Land to North of Rectory Farm, Yatton

Persimmon Severn Valley

Flood Risk Technical Note

January 2024

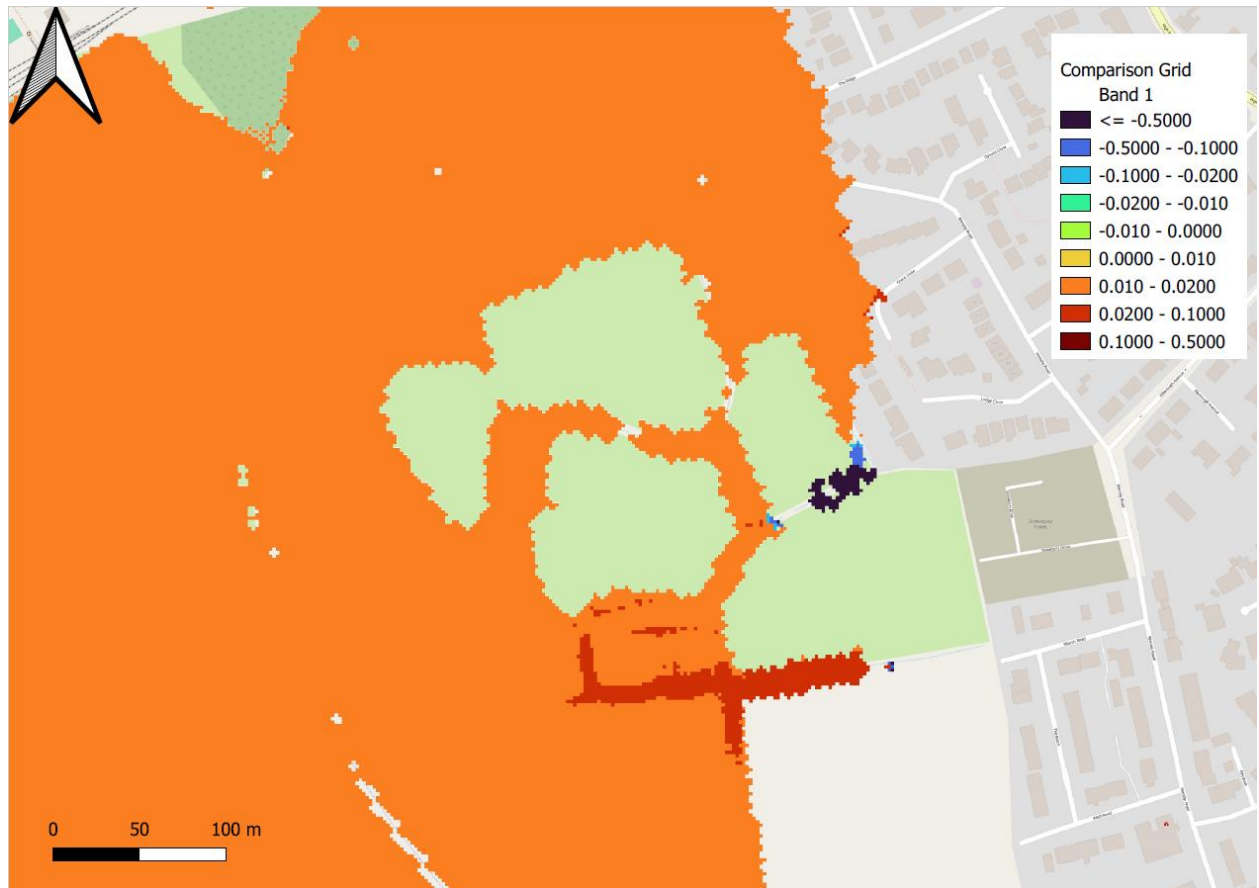
- 4.4 On review of the modelling works undertaken, the proposed ground raising at the site results in all of the proposed development being above the modelled 1 in 200 year plus climate change tidal flood depths, but a comparison of the pre and post development grids has shown that flood depths within the immediately surrounding area do have a variance of a fairly consistent 17mm, see below figure.

- 4.5 The modelling shows flood level variances around the perimeter of the site that affects only a very localised area with no increases being predicted west of the Strawberry Line. On review of the increases, those to the north and south of the site are within farmland areas but those to the east of the site are shown to impact existing properties, and it is this that the EA have commented on.

- 4.11 On review, and as shown on Figure 1, the increases because of the development only impact a localised area around the site boundary impact <10 existing properties. From the available mapping it is unclear whether the buildings themselves are affected or if it is just the gardens. However, and to adopt a conservative approach, it is assumed that the 'properties' are affected.

- 4.13 As a result of the development, the extent of flooding (see below) does not increase and therefore no new properties are 'at risk'. Additionally, the properties where the 17mm fluctuations are predicted are at no 'change of risk' as remain as being Flood Zone 3. It should also be noted that the flood depths within the baseline assessment to these properties (and surrounding farmland) vary from 0.4m to 1.3m within the baseline assessment. These depths are for the defended 1 in 200 year plus climate change event

- 4.18 The revised mitigation approach (i.e. using the defended scenario) has been discussed and agreed with the EA as appropriate. It is this reduced level (i.e. 6.28m AOD) that reduced the third party increase from the quotes 30mm in the Brookbanks report, to the latest value of 17mm (as per submitted modelling files).
